THE
TRIUMPH
MAYFLOWER
CLUB

SERVICE BULLETINS

November 2018 | Paul Burgess

Triumph Mayflower Service Bulletins

“MAYFLOWER” FRONT SUSPENSION REBOUND CABLES.

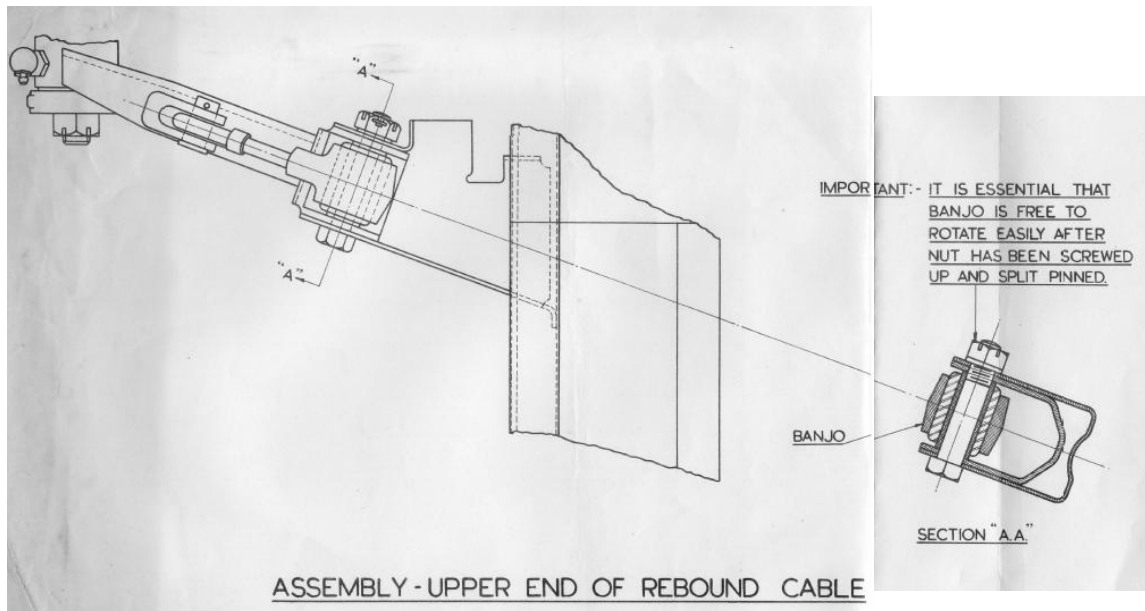
It is particularly important when carrying out Pre-Delivery Checks, or normal maintenance attentions, to Cars equipped with these cables (earlier batches were not so equipped), not to overtighten the bolt shown in Section "AA" in the attached illustration.

Failure to allow free movement of the banjo adaptor at the upper end of these cables, can quite easily cause collapse of the cables concerned.

AUXILIARY DROP ARM - "MAYFLOWER".

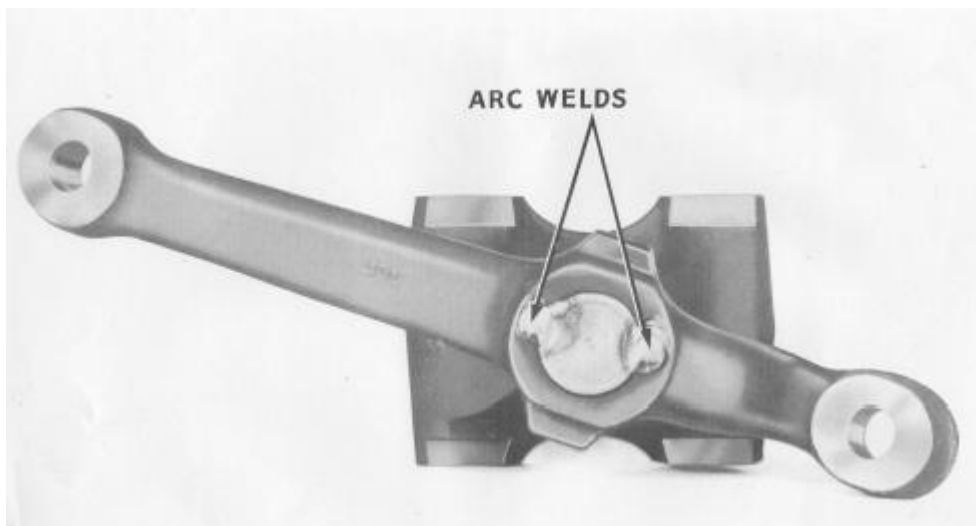
A few instances have been reported, where, owing to an unusual association of machining limits, the pin fit in the lever is insufficiently tight. The possibility of relative movement between these parts can, if not dealt with promptly, allow the spindle to be screwed out of its threaded socket in the bracket.

To prevent any possibility of such a trouble arising with future cars, the machining limits, used in the manufacture of these assemblies, have been suitably modified and the spindle arc welded in position, as shown in the attached illustration.

Any movement between the spindle and the lever can easily be detected by placing the thumb and finger on the parts concerned whilst the steering is moved against the weight of the Car. Where any movement between the lever and spindle is occurring, a replacement Drop Arm Assembly, Detail No. 20013U should be fitted.

The modified machining limits and arc welding of the Drop Arm Spindle to the Lever starts at:-

Commission No.	TT. 5240	for	C.K.D.
	TT. 5463L	for	L.H. Steering
	TT. 5658	for	R.H. Steering

DESCRIPTION.
REVISED REAR AXLE OIL LEVEL

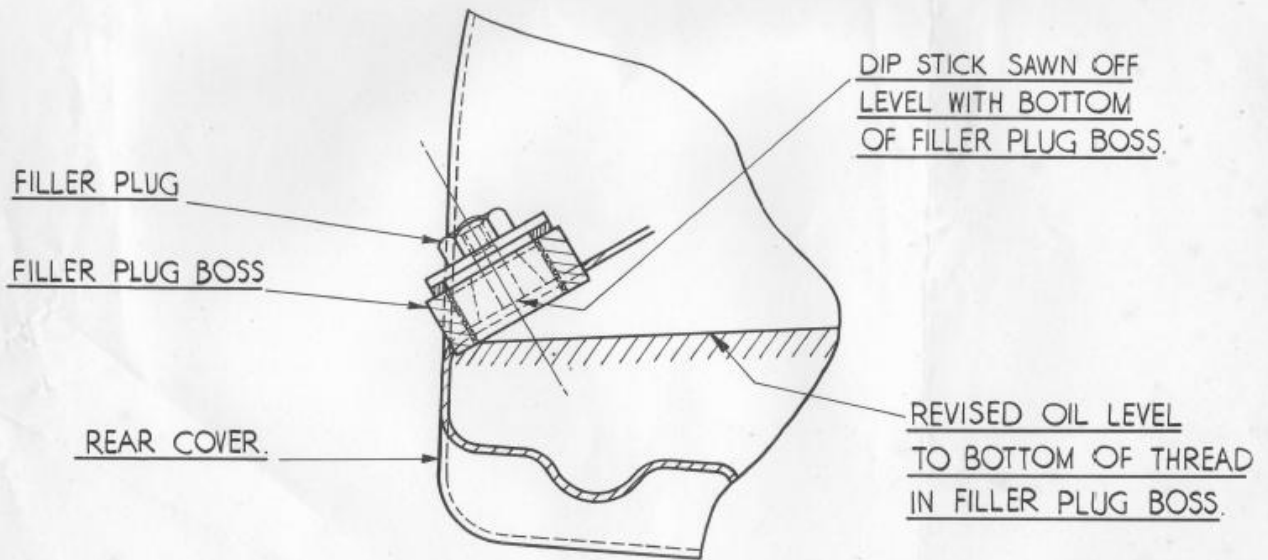
It has been found necessary to raise the oil level in the Rear Axle fitted to this model.

The Dipstick is to be deleted and the axle is now to be filled until the oil reaches the lowest point of the thread, into which the Filler Plug Dipstick Assembly screws. The oil should not now be allowed to fall more than 1/2" below the level shown in the sketch overleaf.

The Rear Axle Dipstick, fitted to Cars of this type should now be cut off with a hacksaw, carefully removing all swarf before refitting.

Existing stocks of Filler Plug Dipstick Assembly, Detail No. 101335, will be modified. This item will be replaced by an undrilled Filler Plug, Detail No. 62058, as soon as existing stocks of the modified parts have been exhausted.

This modification was incorporated in production from Commission No. TT. 6813

LOCKHEED BRAKE MASTER CYLINDER - MAYFLOWER AND VANGUARD.

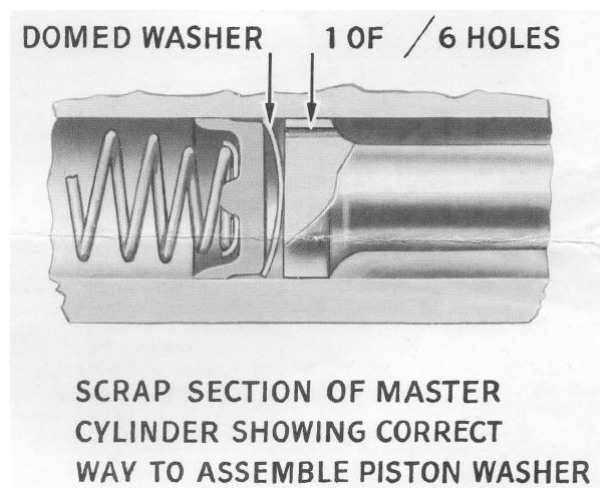
A domed and "coppered" brass shim is interposed between the piston and the main rubber cup. This domed shim is fitted with a view to preventing any possibility of portions of the rubber cup being extruded through the six small holes, in the piston head, and thus interfering with proper recuperation.

The domed shim is fitted with the convex portion towards the top of the piston, as shown in the illustration attached. Thus, when the pressure on the washer is relieved, the shim which flattens under pressure resumes its domed shape and uncovers the recuperating holes in the piston head.

It would appear that the brass shim is causing some form of chemical reaction in the Unit, since the fluid in the region of the rubber cup and shim has, where this difficulty arises, become discoloured and "tacky". To remove any possibility of chemical reaction, these brass shims will, in future, be nickel plated.

If, in cases where this trouble is experienced, the brass shim is removed, the system will operate quite satisfactorily, but the life of the rubber cup will be considerably reduced and this procedure should only be adopted as a temporary measure, where a nickel plated shim is not available.

Supplies of the nickel plated brass shim, Detail No. 103020, can be obtained from our Spares Department.

Coil to distributor H.T. Cable

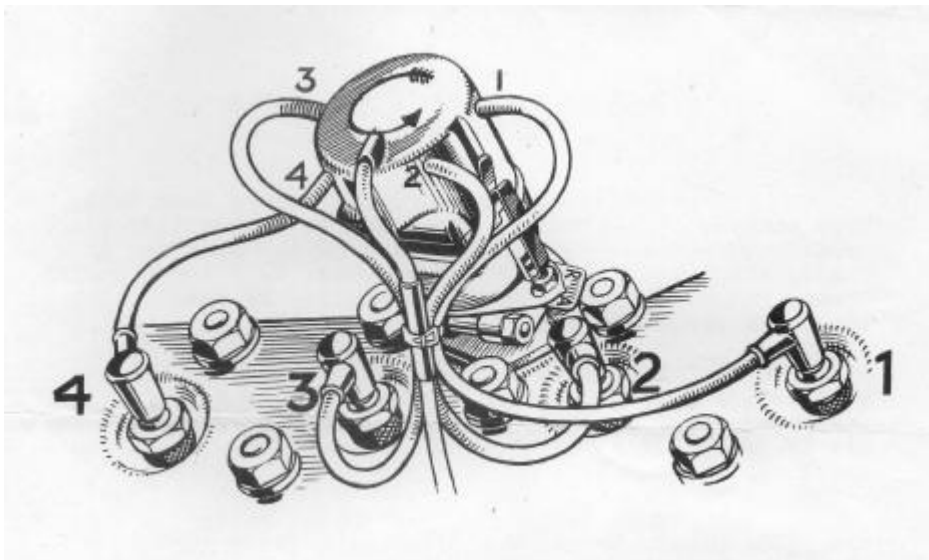
Instances have occurred, where this cable has been severed by vibration, when used in conjunction with the radio suppressor. The introduction of the sparking plug lead cleat, which was fitted to prevent Nos. 1, 2 and 3 cables making metallic contact with the engine, by restricting vibration, has prevented further fracture of this cable.

The cleat is shown fitted, in the illustration overleaf its incorporation necessitating the lengthening of the three front sparking plug leads. The new length of leads is 11.7/8", 8.1/8" and 10.3/4", respectively, for Nos. 1, 2 and 3 cylinders.

When replacing this cable, following failure, the cable cleat, detail No. 60527, should be installed together with the necessary longer leads. The cable cleat may be obtained from our Spares Department.

The cable locating cleat and longer leads, were introduced in normal manufacture on engine No. TT.7487E and future, or on finished cars, at Commission TT.7413.

DESCRIPTION.	SERIES
REPLACEMENT OF CLUTCH OPERATING RODS 101106 & 101111 BY CLUTCH OPERATING ROD 106427 - 2 OFF.	20ST.

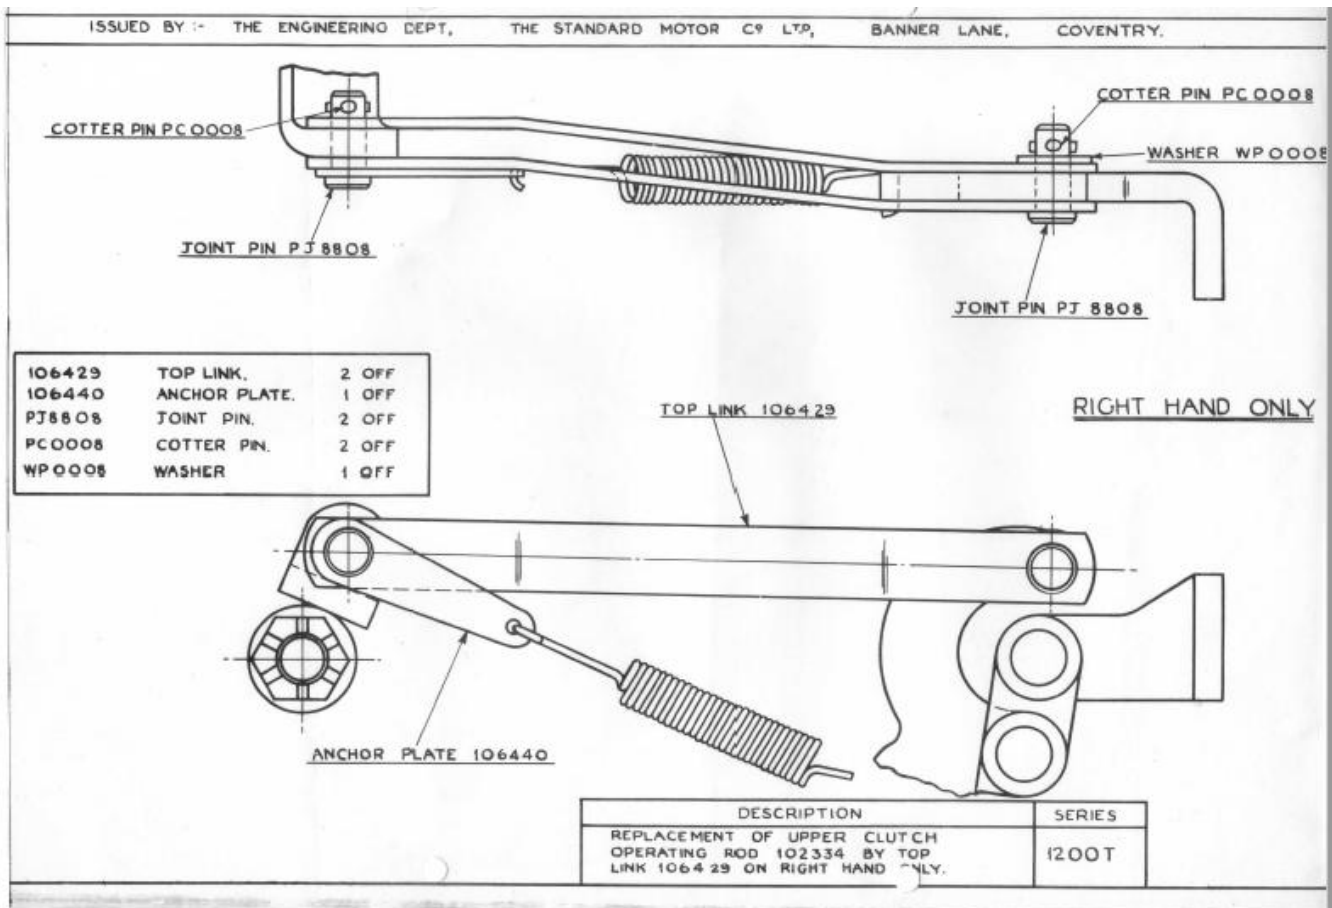
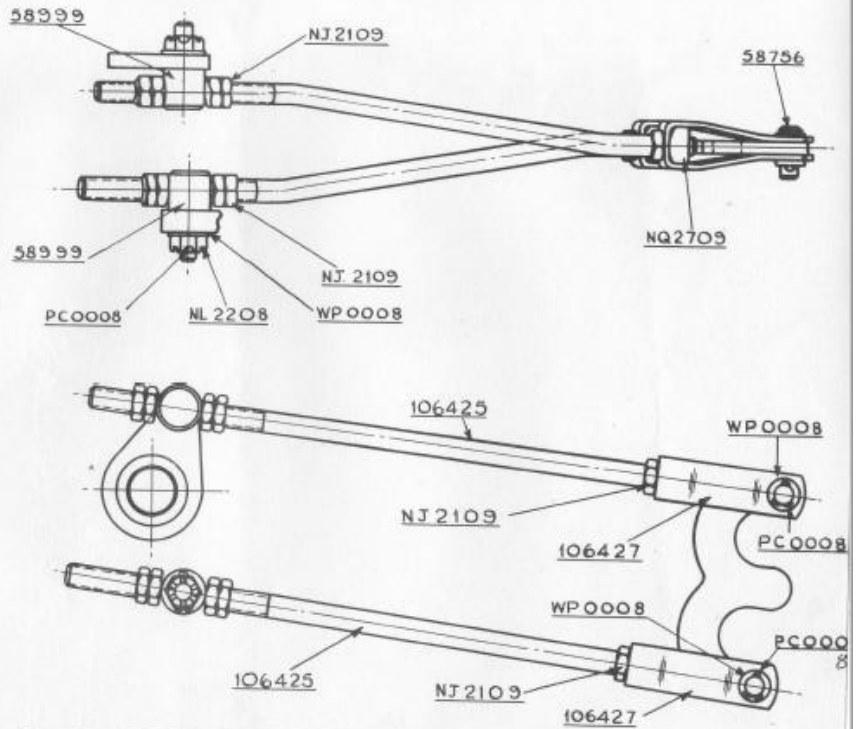
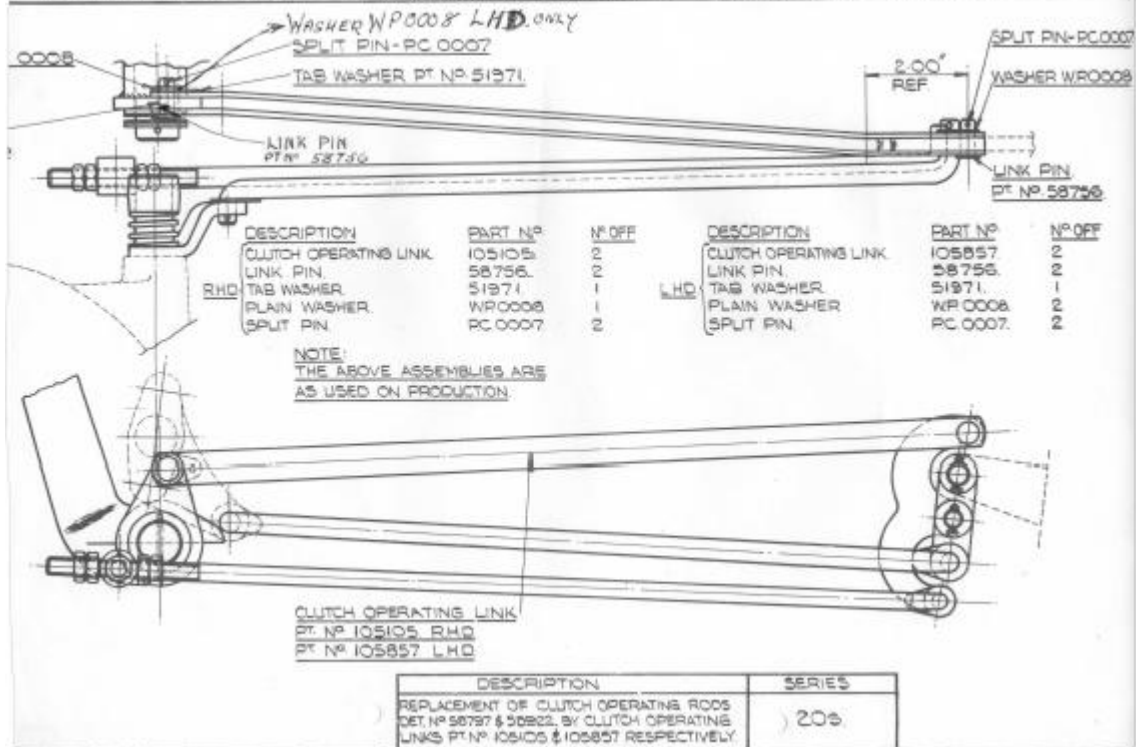
Since manufacture of these models commenced a modification has been introduced in connection with the Top Clutch Operating Rod. This alteration was made with a view to eliminating the sharp bends at each end of the rod, which were previously used. These rods have proved susceptible to fatigue fracture, where large mileages, or exacting conditions of clutch operation, are involved.

Repairers are recommended to make this modification when fitting a new clutch assembly, as the installation of such a unit is likely to precipitate a failure of a fatigue nature.

106425	CLUTCH OPERATING ROD.	2 OFF
106427	COMPENSATOR END.	2 OFF
58999	SWIVEL PIN.	2 OFF
NL 2208	NUT - SLOTTED.	2 OFF
NQ.2709	NUT - SQUARE.	2 OFF
N.J. 2109	NUT - JAM.	10 OFF
58756	JOINT PIN.	2 OFF
WPO008	WASHER - PLAIN.	6 OFF
PC0008	COTTER PIN.	4 OFF

DESCRIPTION	SERIES
SCHEME FOR RAISING COMP RATIO TO SUIT PREMIUM FUELS.	1200T

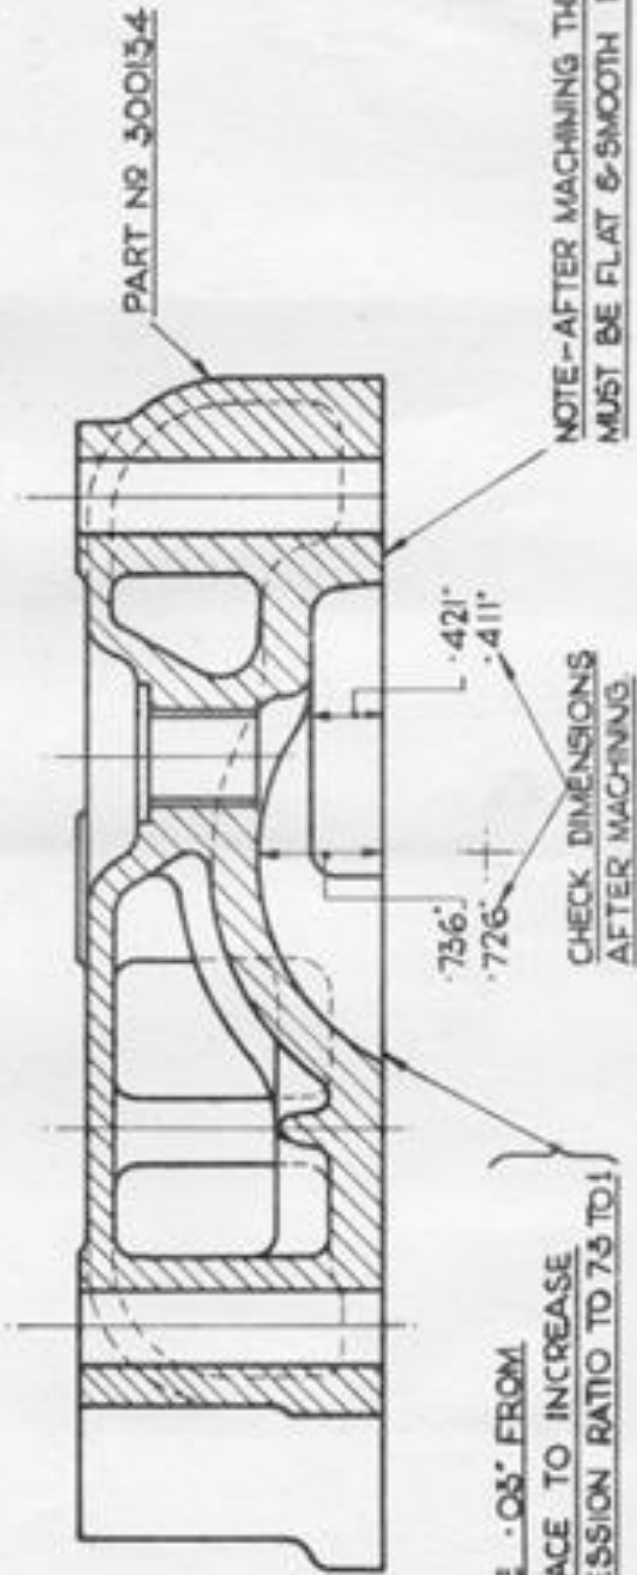
The attached sketches give complete instructions for carrying out a modification to compression ratio should it be requested by a customer. The early Two Litre Engines had a compression ratio of 6.7, whilst after V.135001E and TDC.5094B for the Standard and "Renown" respectively, this was increased to 7 (identification details given in Service Bulletin No. V.79G.)

The thickness of the bottom wall is very important and owners should be encouraged as far as practicable to limit the machining of both the earlier and later type of cylinder head to .040", giving 7.2 and 7.25 compression ratios respectively. The respective head designs will give about the same susceptibility to "pinking" at the ratios quoted and the improvement in performance should fully satisfy most customers. Should a customer insist upon the removal of the maximum 0.070", the bottom wall thickness must first be ensured. As stated in the attached Scheme, the bottom wall thickness must not be less than .250" minimum (it will not be uniform) after machining.

The Mayflower Engine which has a compression ratio of 6.8, may also be modified as shown in the attached sketch and in this case the ignition should be set either on the point of pinking " or at T.D.C.

REMOVE .03" FROM
JOINT FACE TO INCREASE
COMPRESSION RATIO TO 7.5 TO 1

NOTE - AFTER MACHINING THIS SURFACE
MUST BE FLAT & SMOOTH FINISH.

CHECK DIMENSIONS
AFTER MACHINING

REPLACING GEAR CHANGE CROSS-SHAFT BEARINGS – TRIUMPH MAYFLOWER AND TWO LITRE STANDARD MODELS.

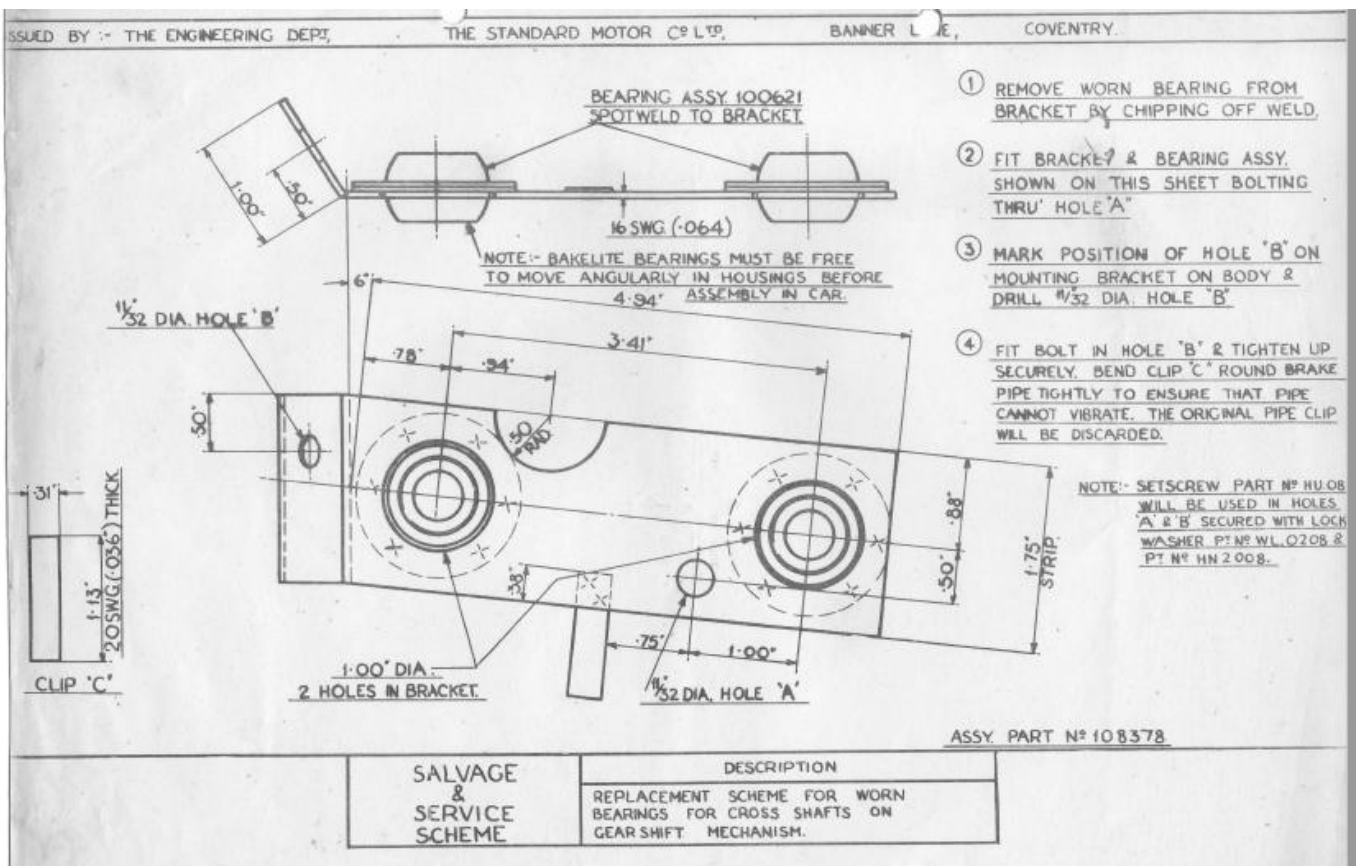
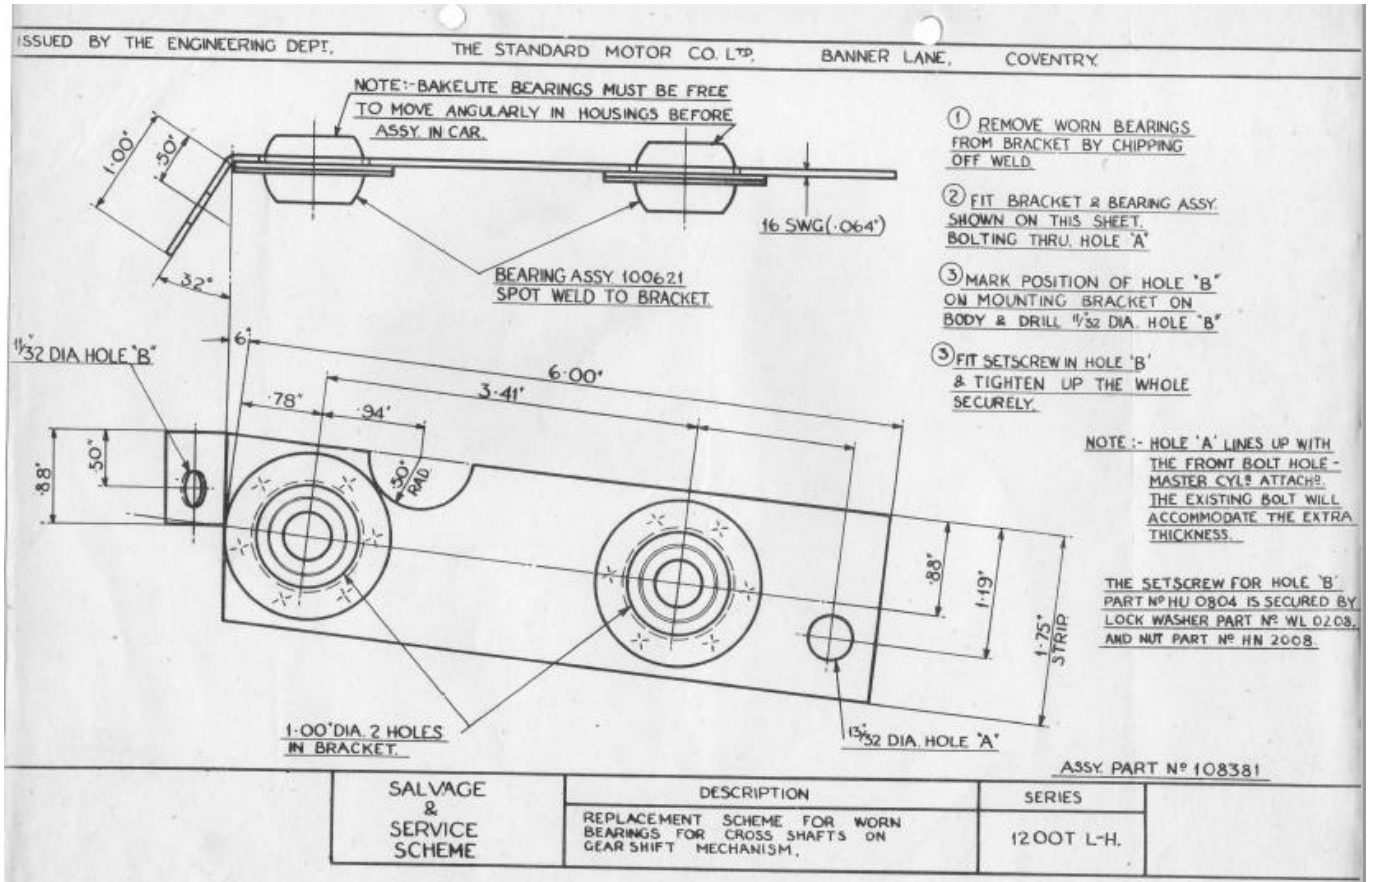
Where replacements have to be fitted, the existing bearings and their housings should be removed and replaced by the assemblies, as explained in the attached Service Schemes.

The replacement assemblies. Part Nos. 108381 and 108378 for L.H. and R.H. steering Models respectively, will not be available immediately, but the inevitable time taken in the preparation of Manufacturing tools, etc. is not likely to cause any serious delay in obtaining supplies through normal Spares channels.

In cases where there is an urgent need for fitting replacements, sufficient details are given in the Service Schemes to enable self manufacture of the brackets, whilst the bearings, Part No. 100621, are readily available from our Spares Department. To meet such cases the necessary bolts, etc, will, no doubt, be available from local sources.
